Mercury Firmware Release Notes

Version 2.2.6.20 • 18 March 2016

Oxford Instruments NanoScience

Figure 6. Remote lock (left) and unlock function (right).

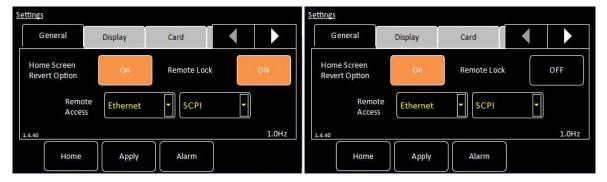
The new release allows for remote unlocked operation. When the remote lock is on, no feature in the unit is available for manipulation from the front screen. When the remote lock is off, only the settings features are disabled; allowing users to control their system from the front screen. The remote lock feature can be activated locally or remotely. The remote activation of the lock feature can be hard (SET:SYS:LOCK:ON) or soft (SET:SYS:LOCK:SOFT). In the first case, the user will not be able to deactivate it from the front screen (i.e. the navigation buttons will also be disabled). In order to turn off this feature remotely use the command SET:SYS:LOCK:OFF.

Figure 6. Pressure Sensor Details

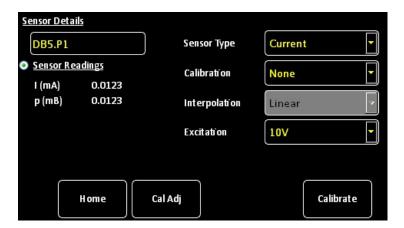
Version 1.4.40 has full pressure sensor support.
